ASSESSMENT REPORT

Orange Waste Project - Site Layout Changes (MOD 1)

Figure 4: Approved and proposed ERRRC site layout

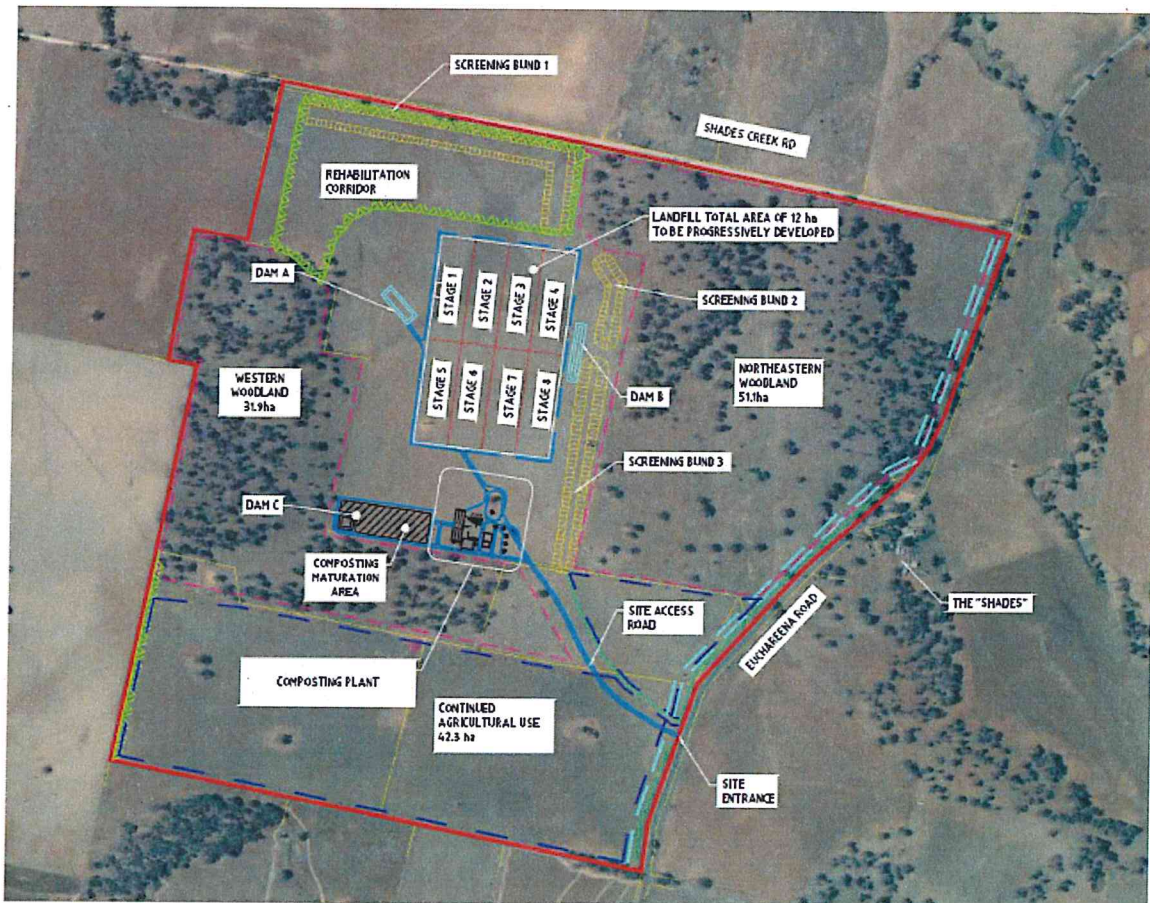
- rearranging the layout and orientation of the composting buildings and infrastructure;
- replacing the water storage Dam C with 5 separate dams (C1 to C5);
- modifying the internal road network and reducing the amount of car parking spaces;
- relocating the weighbridge to the south;
- relocating the maintenance shed and landfill office to the north-east;
- relocating the education facilities to the ORRRC; and
- changing the colour of the buildings in order to be corrosion resistant.

A number of public submitters raised concern about the presence of a shredder at the ERRRC site on the original modification plans and subsequent noise impacts. Further, CC and a number of submitters (eg. the Hub Action Group) also raised concern that the proposed design (enclosed on three sides with an open end) and alignment of the organics receival building at the ERRRC site would increase noise at nearby sensitive receivers.

Cabonne Council and a number of public submitters (eg. the Hub Action Group) raised concerns that the proposed design (3 enclosed sides with an open end) and alignment of the organics receival building at the ERRRC site would increase odour impacts on nearby sensitive receivers.

In response to these concerns, OCC has clarified that the shredder was shown in error on the original plans and would only be located at the ORRRC site.

In regard to the design of the organics receival building, OCC clarified that the original noise assessment modelled noise emissions based on all plant and equipment operating directly and concurrently, without the presence of an enclosed building structure. Given that the organic receival area would now be partially enclosed, OCC's acoustic experts advise that the actual noise levels would be lower than those predicted in the original EA.

In response to this concern, OCC confirmed that the original air quality assessment for the approved project was undertaken on the assumption that this building was not enclosed on any side. In this regard, OCC notes that the proposed modification is therefore not expected to have a greater impact on air quality than originally approved.

Figure 5: Approved and proposed ERRRC site dam and composting area comparison

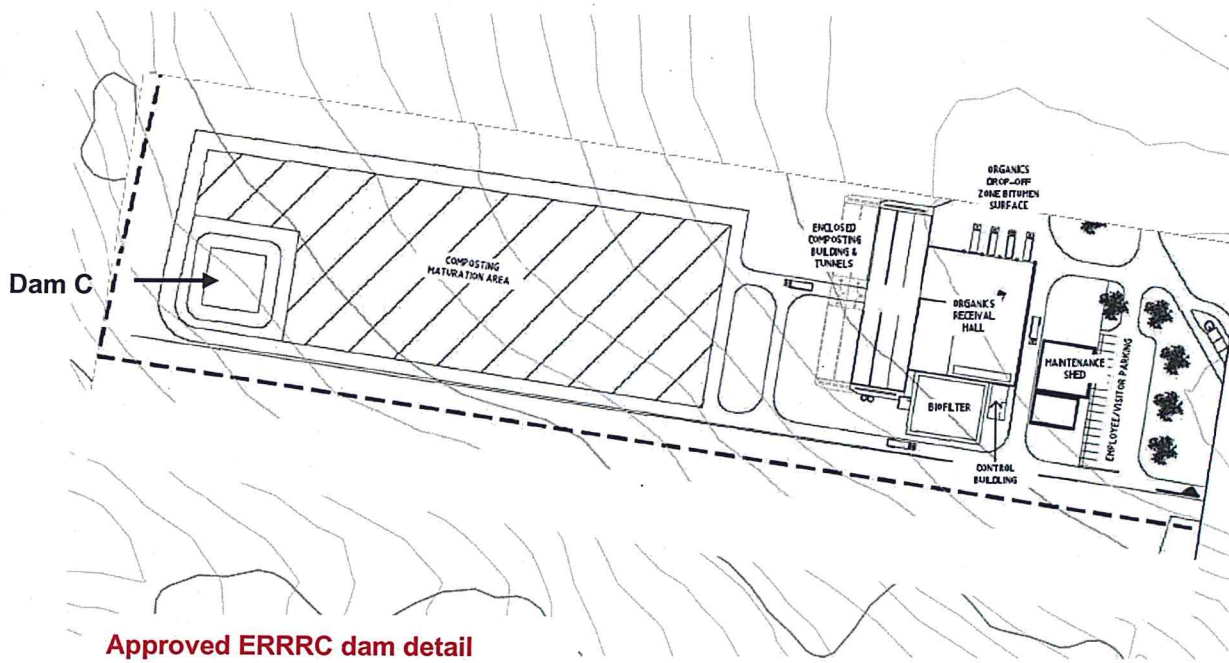
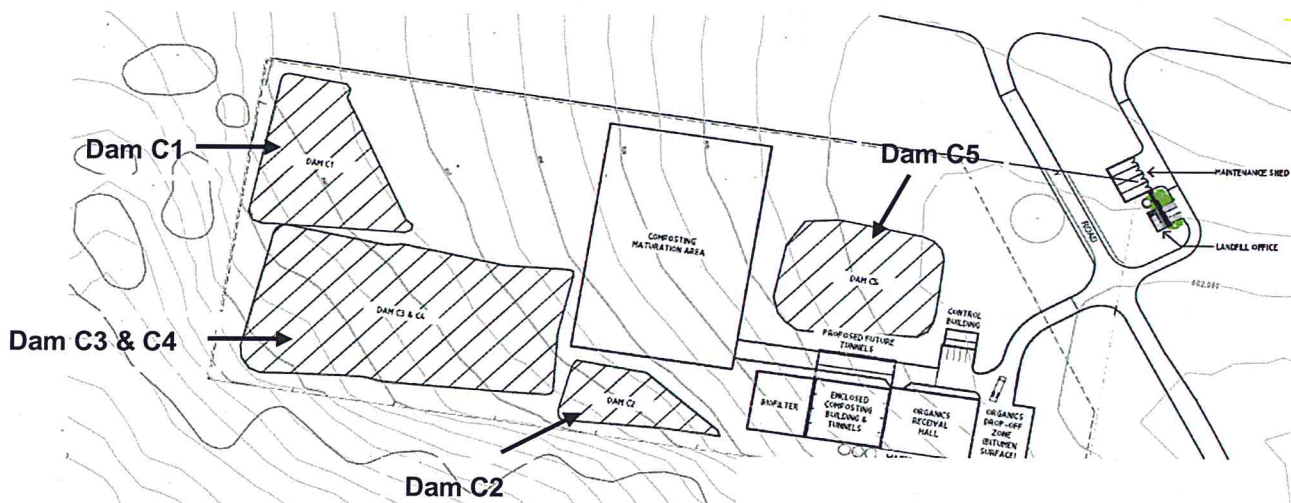
A number of submitters raised concerns about the plans in the original modification, which only illustrated the proposed reconfiguration of Dam C. Concerns were raised that since the plans did not show the other approved surface water dams (A and B) at the ERRRC site, that these dams could potentially have been removed from the site.

Cabonne Council and a number of public submitters (eg. the Hub Action Group) also raised concerns that the overall capacity of Dam C had increased from 0.5 to 10 mega litres (ML) which would exceed harvestable rights for the ERRRC site.

In its RTS report, OCC provided amended plans of the ERRRC site to show all current and proposed surface waters dams. OCC clarified that the proposed modification did not seek to change Dams A and B (located adjacent to the landfill area) which would remain in accordance with the current approval. The proposed modification would see Dam C, located in the vicinity of the composting facility at the ERRRC site, separated into five (5) separate dams (Dams C1–C5) (see Figures 4 - 5) with an increased water storage capacity.

OCC indicated that following the project's approval, detailed water balance analysis had been undertaken which concluded that the original water requirements for the ERRRC site had been under estimated (ie 0.5 ML) and that around 5 ML of water would be required for its operational activities.

Dams C1-C5 would now have a combined capacity of around 10 mega litres. OCC indicated the extra capacity in Dam C would enable the composting facility to store sufficient water for operational needs without any of the dams needing to be at 100% capacity (ie less than 10 ML). The increased capacity would also ensure that surface runoff during periods of high rainfall can be adequately accommodated, thereby preventing any uncontrolled release of liquid residue from the site into the local water environment.

Further, OCC advised that the function of Dams C1-C4 would remain unchanged for that which was approved and will serve to collect water (including stormwater) from the composting operation areas for re-use in the composting process. The function of Dams C1 and C2 would be for the capture and reuse of stormwater that has potentially been in contact with treated compost. Dam C3 would capture residual runoff from the composting process in addition to providing top up water for the compost process. Dam C4 would be kept less than 20% full and act as a back up for C3 in times of high rainfall. Dam C5 would be used as a fire fighting resource.

The dam design would remain consistent with the approval design incorporating a 900mm clay lined closed system where no discharge occurs. The compost maturation area would be bunded to prevent leachate run-off into surrounding soils.

In terms of harvestable rights, OCC has responded by suggesting that because Dams C1-C4 would serve as a pollution control function (ie collecting leachate water from the compost maturation area), the dams would be exempt from harvestable rights requirements.

The Department discussed this issue with NOW, who has confirmed that since the Dams would be used to store rainwater harvested from the roofs of the buildings and maturation area and not for capturing overland flow from clean areas, this method of collection is not considered within the harvestable rights calculations.

Furthermore, the Department has also recommended additional conditions to ensure that the additional dams (C1-C5) are also constructed in a manner to include 900mm of clay lining material to manage any seepage issues.
